City of Placerville

ADDENDUM NUMBER 1
Dated: July 27, 2020

SPRING STREET PAVEMENT REHABILITATION CIP #41907 AND MOSQUITO ROAD STABILIZATION CIP #41819
City of Placerville

PROJECT NO. 6884.010 & .011
SHEET NO. C06 OF C14

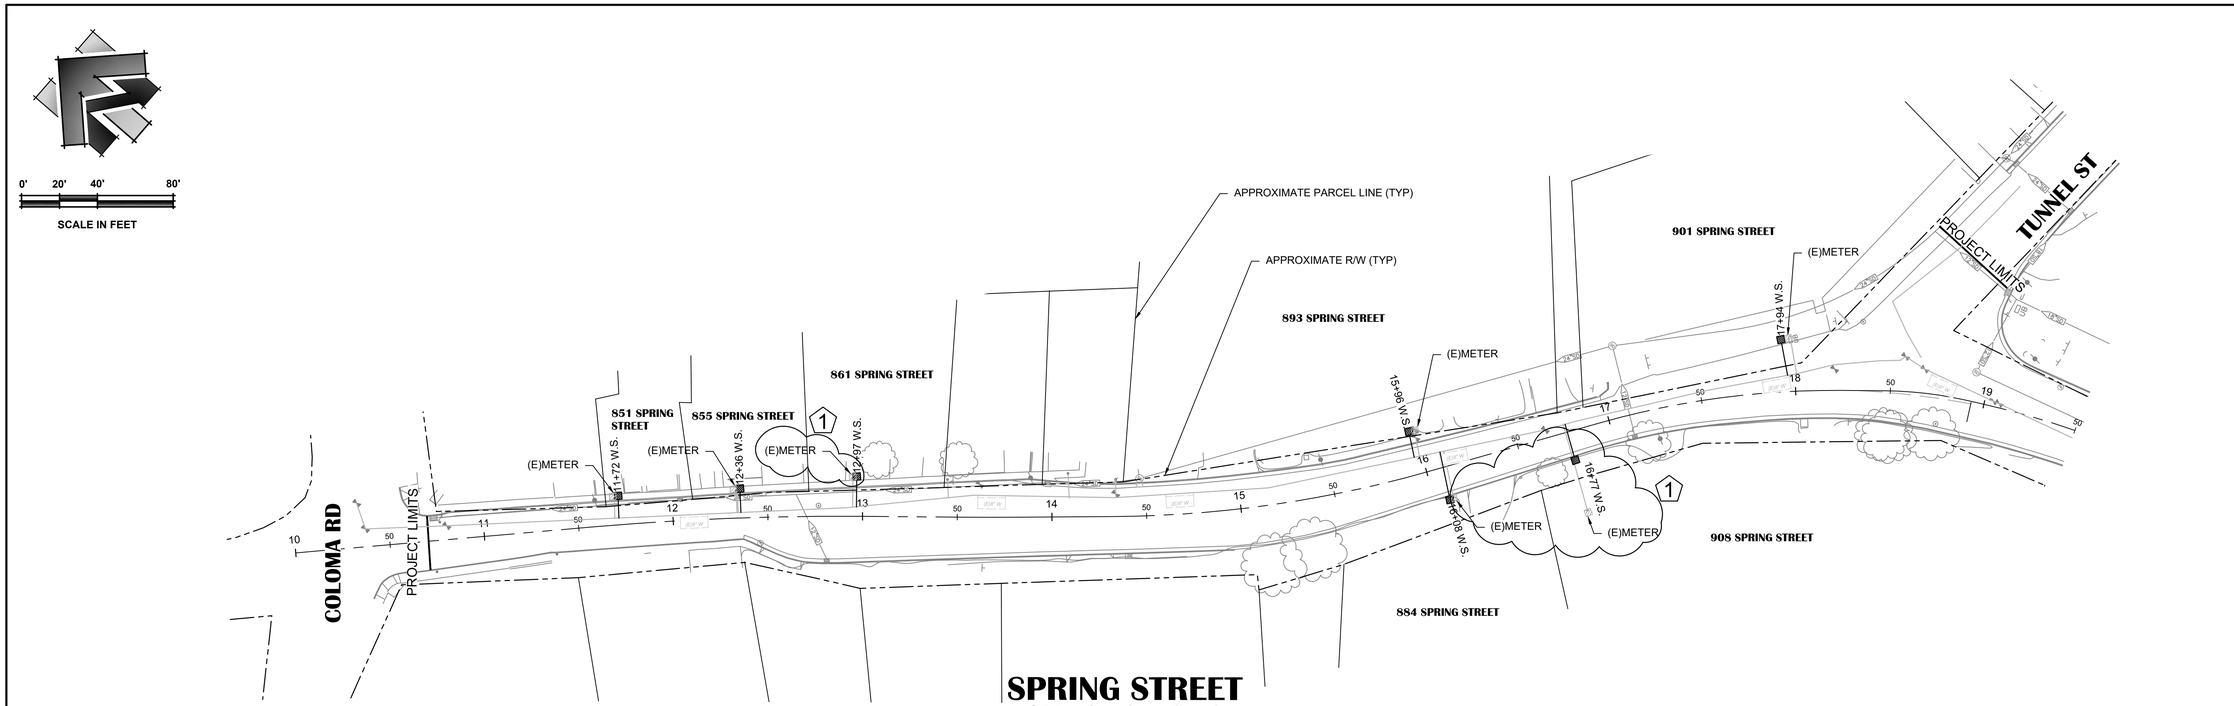
Note 8 on Sheet C06 (which stated that the existing services are to be abandoned) has been deleted by Item No. 2 in this Addendum.

Answer: The water service locations have been updated on Sheet C06 per Item No. 4, below. Note 6 on Sheet C06 (which stated that the contractor was to field verify the location of these existing services) has been deleted by Item No. 5 in this Addendum.

Regarding Plan Sheet C06, revise locations of existing water meters for 861, 884, and 908 Spring Street. Revised location of proposed water meter for 908 Spring Street.

6. ~~LOCATION OF (E)METERS FOR 861, 884, 908 SPRING STREET IS UNKNOWN. CONTRACTOR TO VERIFY LOCATION IN THE FIELD.~~ 1
7. INSTALL NEW SERVICE PIPING, METER AND METER BOX PER DETAILS, THIS SHEET.

8. ~~WHEN CONNECTING SERVICE TO (E)MAIN, ABANDON (E)SERVICE AT (E)CORP STOP AND ABANDON IN PLACE.~~ 1
9. IF NECESSARY, SAWCUT (E)SIDEWALK, (E)CURB AND (E)GUTTER @ JOINT AND REPLACE IN KIND.

Regarding Plan Sheet C06, Delete Note 8 which states:

WHEN CONNECTING SERVICE TO (E)MAIN, ABANDON (E)SERVICE AT (E)CORP STOP AND ABANDON IN PLACE.

Regarding Plan Sheet C06, Delete Note 6 which states:

LOCATION OF (E)METERS FOR 861, 884, 908 SPRING STREET IS UNKNOWN. CONTRACTOR TO VERIFY LOCATION IN THE FIELD.

WATER SERVICE TYPE 1 - REPLACEMENT SCHEMATIC
N.T.S.

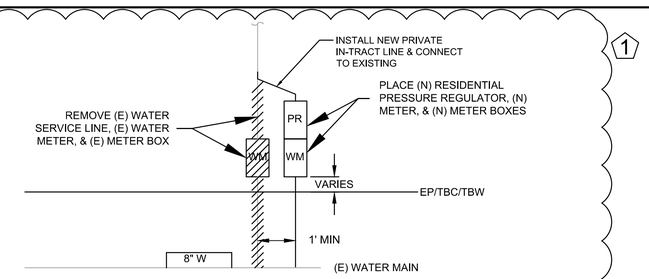
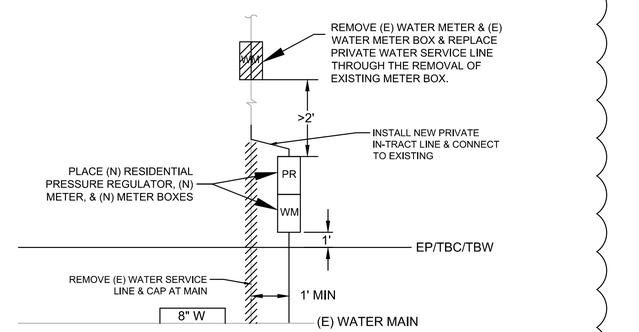
Water service details have been revised by Item No. 3 in this Addendum to show removal of existing water service lines.

Item No. 3: **Revised Details:**
Regarding Plan Sheet C06, revise details for Water Service Type 1 and Water Service Type 2.

NOTES:
1. METER AND SERVICE LINE SHALL BE 1" UNLESS OTHERWISE NOTED.
2. SERVICE LINE, SERVICE SADDLE, AND COUPLINGS SHALL BE PER 1" SERVICE INSTALLATION DETAIL, THIS SHEET.
3. (N) METERS, (N) PRESSURE REGULATORS, AND (N) METER BOXES SHALL BE PROVIDED BY THE CITY.
4. REMOVE EXISTING SERVICE LINE AND CAP AT MAIN.
5. REPLACE (E) LANDSCAPE IN AREA OF DISTURBANCE IN KIND.

NOTES:
1. USE TYPE 2 IN CASE PROPOSED METER IS INSTALLED MORE THAN 2' IN FRONT OF THE EXISTING METER, AS IN LOCATION OF 908 SPRING STREET.
2. METER AND SERVICE LINE SHALL BE 1" UNLESS OTHERWISE NOTED.
3. SERVICE LINE, SERVICE SADDLE, AND COUPLINGS SHALL BE PER 1" SERVICE INSTALLATION DETAIL, THIS SHEET.
4. (N) METERS, (N) PRESSURE REGULATORS, AND (N) METER BOXES SHALL BE PROVIDED BY THE CITY.
5. REPLACE (E) LANDSCAPE IN AREA OF DISTURBANCE IN KIND.
6. REPLACE PRIVATE WATER SERVICE LINE THROUGH THE REMOVED EXISTING WATER METER BOX.

SHEET NO. C10 OF C14

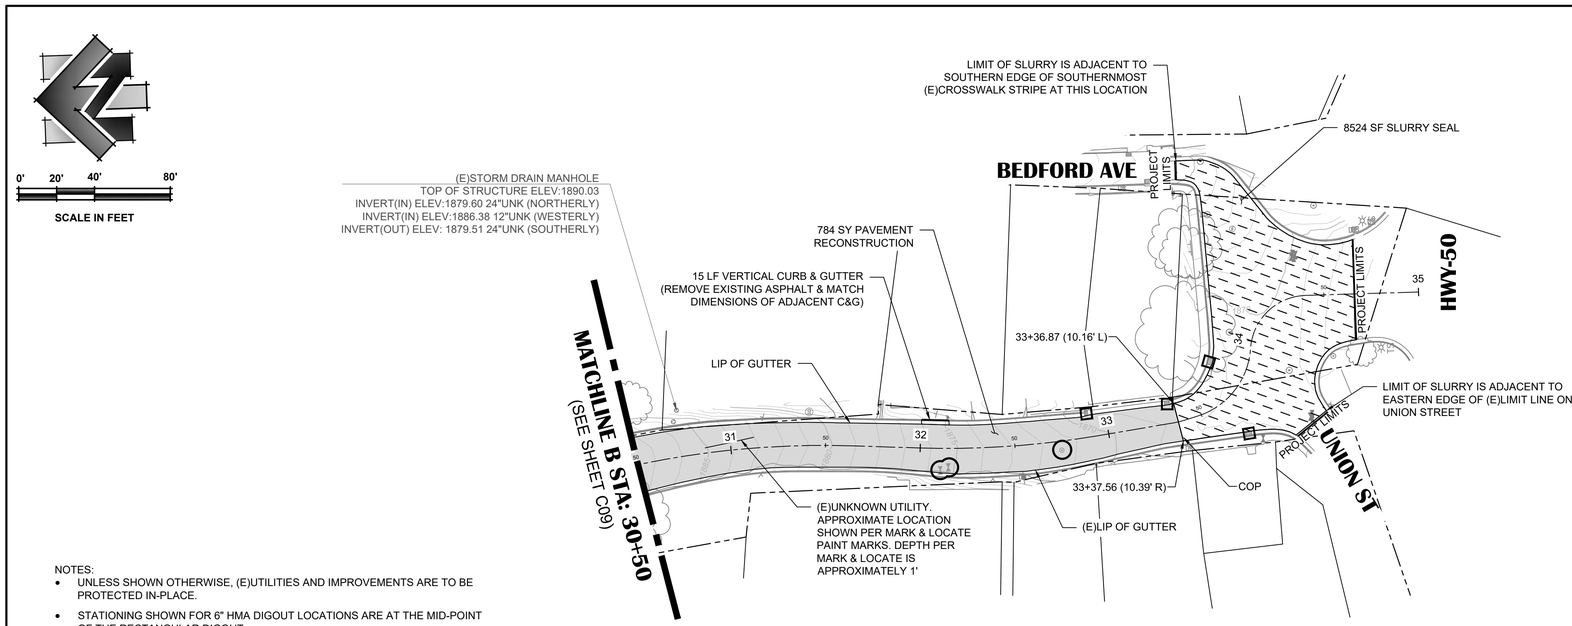
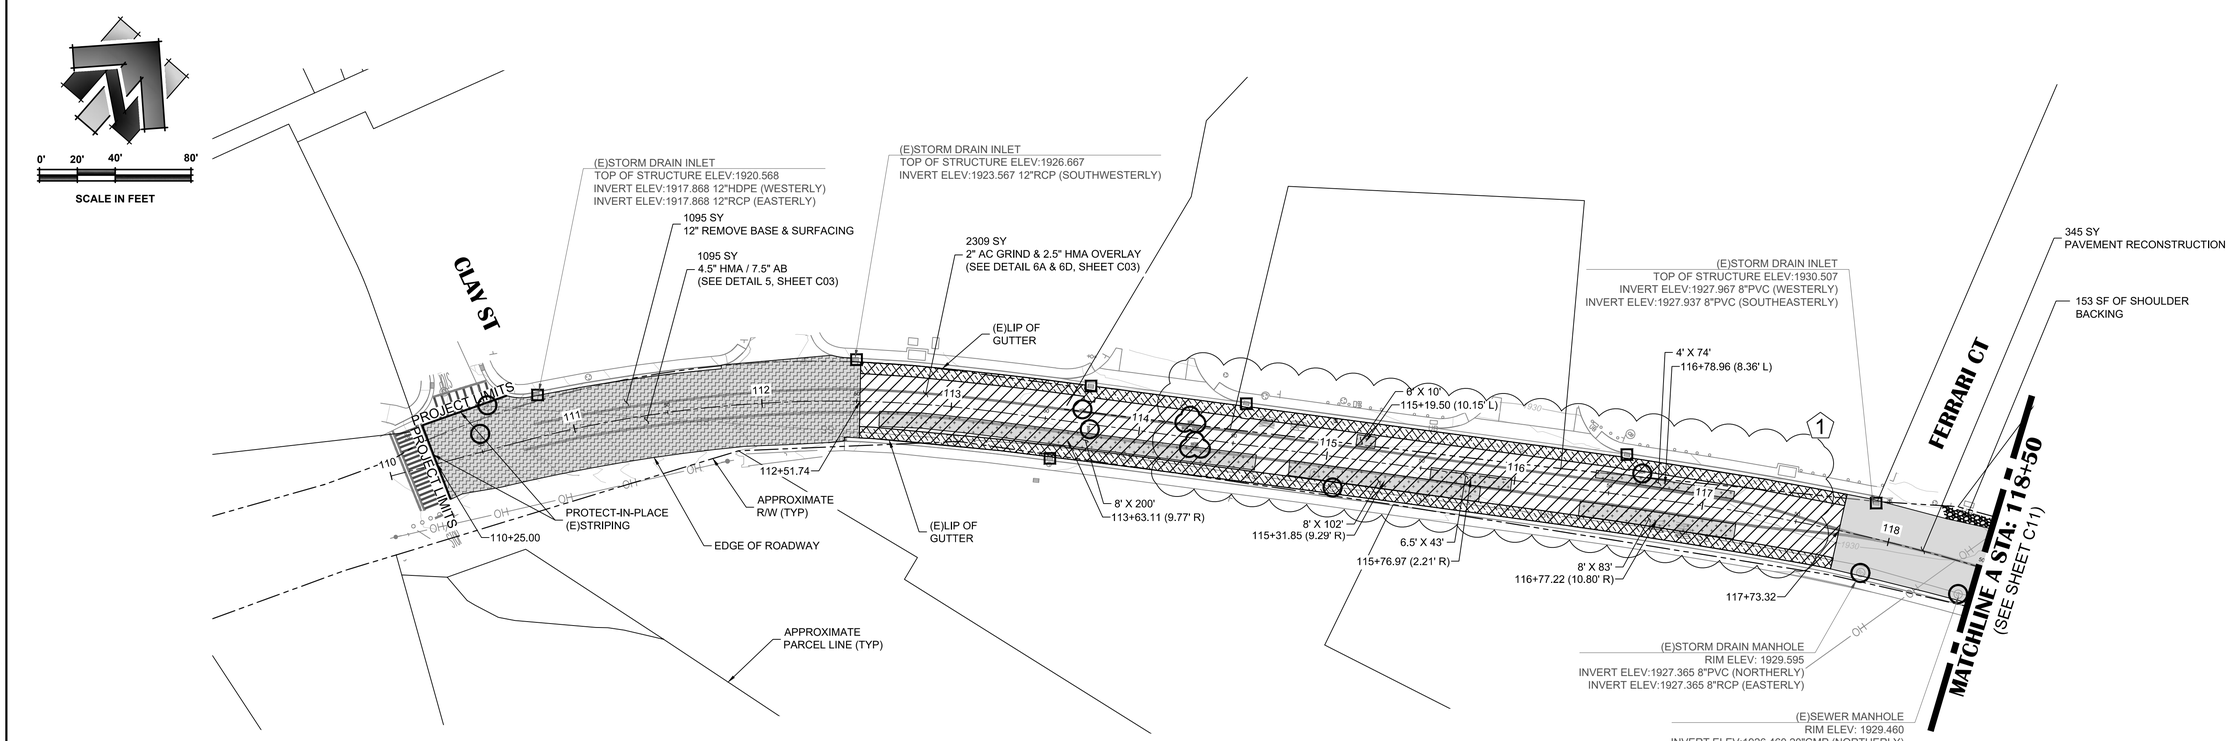
Regarding Plan Sheet C10, revise to show fewer digout areas between stations 114+00 and 118+00 on Mosquito Road.

NO.	REVISION DESCRIPTION	CHECKED BY	DATE
1	REDUCED DIGOUT AREAS	JWF	7/27/2020

PROJECT NO. 6884.010 & .011
SHEET NO. C11 OF C14

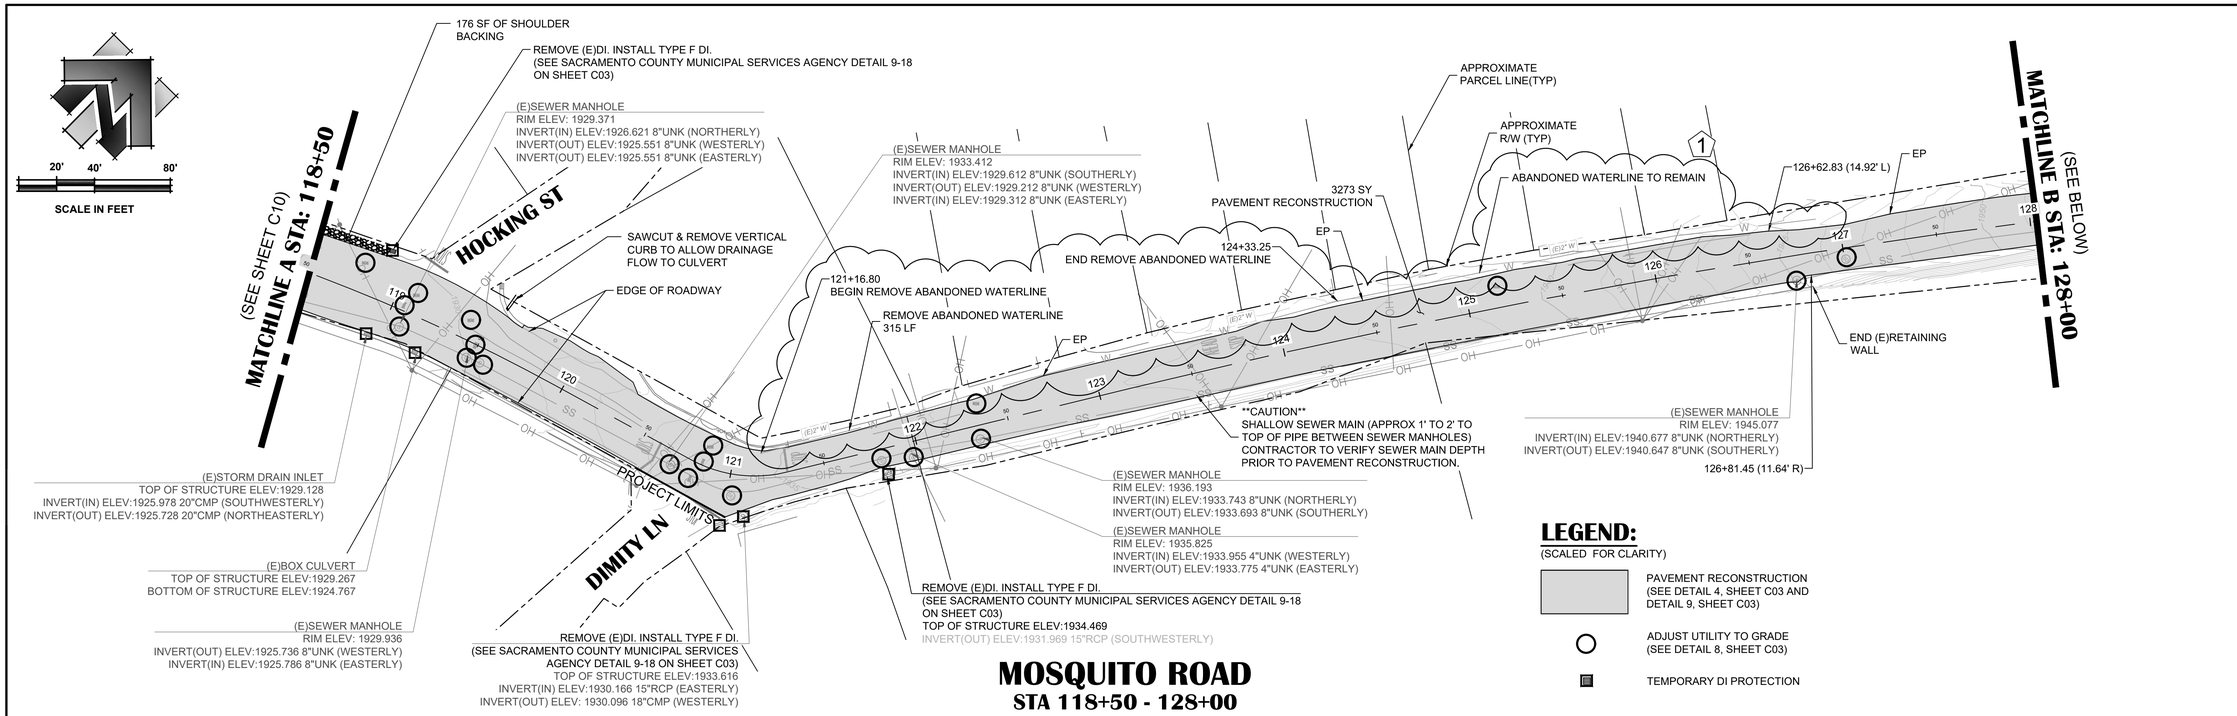
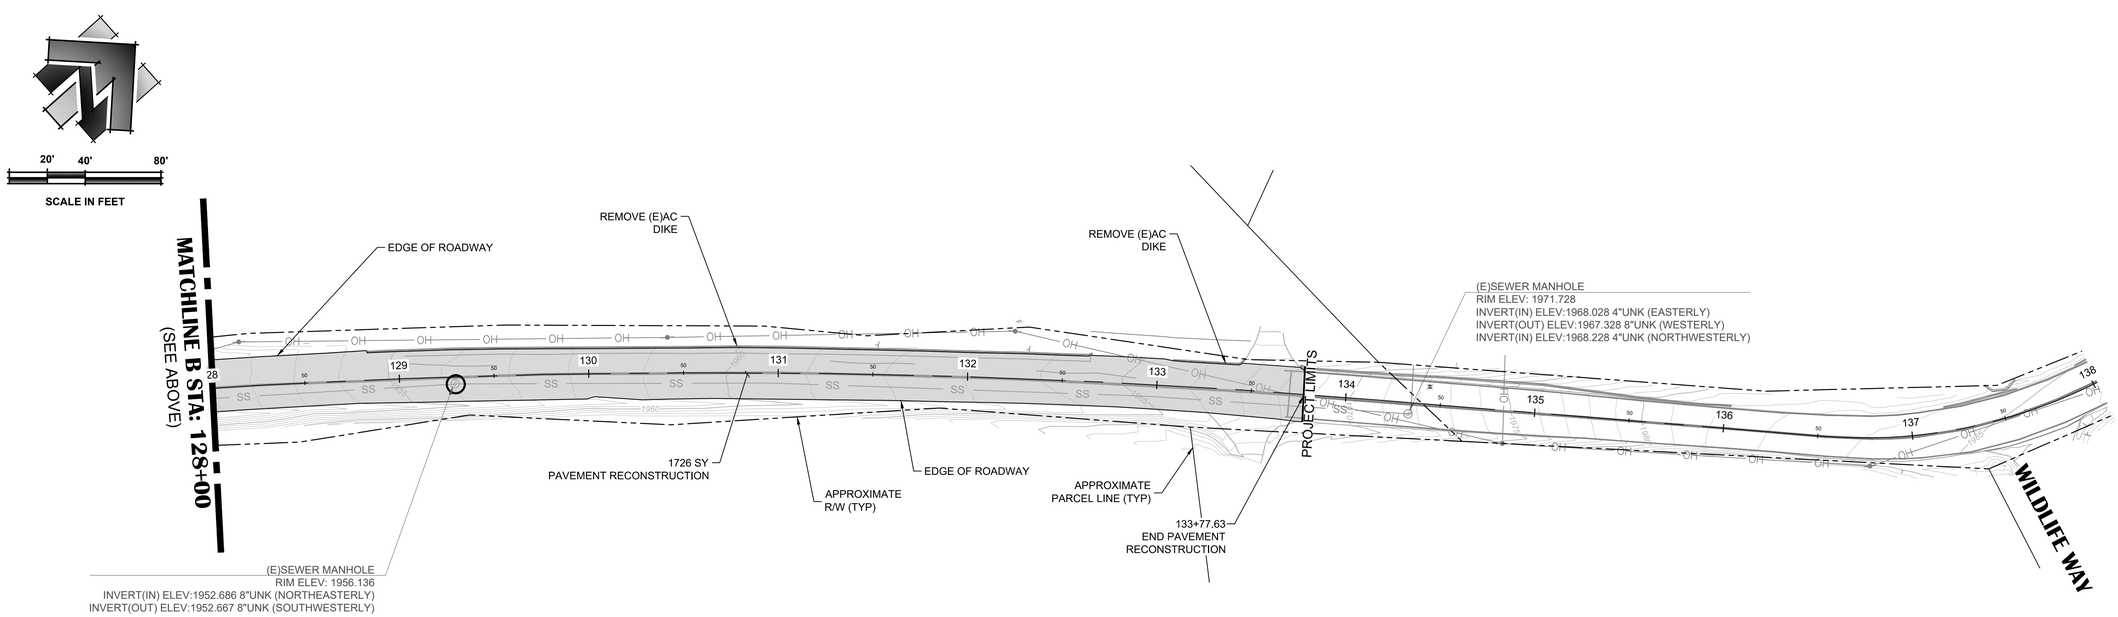
Regarding Plan Sheet C11, show a portion of an existing 2" abandoned waterline to be removed, along the northwest side of Mosquito Road.

NO.	REVISION DESCRIPTION	CHECKED BY	DATE
1	SHOW ABANDONED WATER PIPE TO BE REMOVED	JWF	7/27/2020
